# Access Compliance Report

## Public Rights-of-Way

Intersection ID: N/A	Main Street: ARCHDALE DR	Cross Street: NATIONS_FORD_DR	Location: SE
ADA ID: 330C5E6D38CC	Ramp Type: PerpDiag	Initial Pass/Fail: Fail	Overall Compliance: No
Codes/Mitigation Info/Possible Solution		Field Measurements/Component Compliance

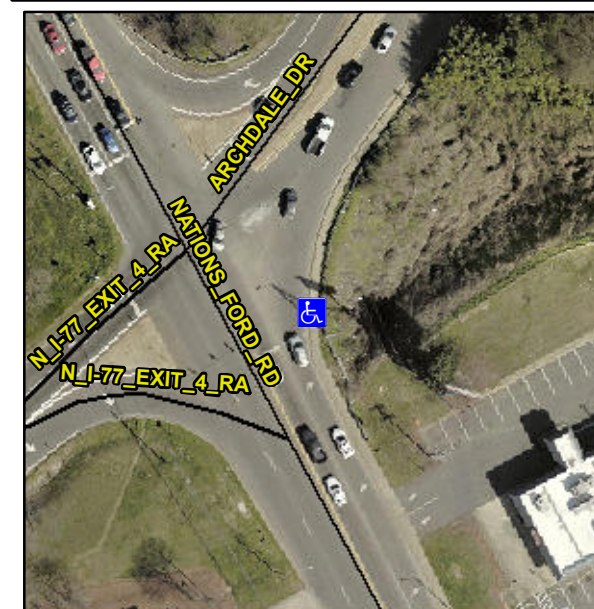
**Not Found, R304.5.1, R304.2.2**

Compliance	Description	Data	Compliance	Description	Data
N/A	Ramp Length (in)	62.0	No	Ramp Slope (%)	8.6
No	Ramp Width (in)	47.0	Yes	Ramp XSlope (%)	0.3
N/A	Flare Type LT	N/A	N/A	Flare Type RT	N/A
N/A	Flare Slope LT (%)	N/A	N/A	Flare Slope RT (%)	N/A
N/A	Flare Traversable LT?	N/A	N/A	Flare Traversable RT?	N/A
N/A	Landing Length (in)	N/A	N/A	DWS Provided?	N/A
N/A	Landing Width (in)	N/A	N/A	DWS Contrast?	N/A
N/A	Landing Slope (%)	N/A	N/A	DWS Length (in)	N/A
N/A	Landing X Slope (%)	N/A	N/A	DWS Full Width?	N/A
N/A	Landing Curb? (Y/N)	N/A	N/A	DWS Offset (in)	N/A
N/A	Shared Landing?	N/A			
N/A	Gutter Ponding?	N/A	N/A	Gutter Slope (%)	N/A
N/A	Gutter Lip Ht (in)	N/A	N/A	Gutter X Slope (%)	N/A
N/A	Painted X Walk1?	No	N/A	Painted X Walk2?	No
	X Walk 1 Direction	To N		X Walk 2 Direction	To W
N/A	X Walk 1 Width (in)	N/A	N/A	X Walk 2 Width (in)	N/A
	X Walk 1 Slope (%)	0.2		X Walk 2 Slope (%)	0.8
	X Walk 1 X Slope (%)	0.9		X Walk 2 X Slope (%)	0.3

**Remove & Replace Curb Ramp With Two New Directional Ramps or Equivalent.**
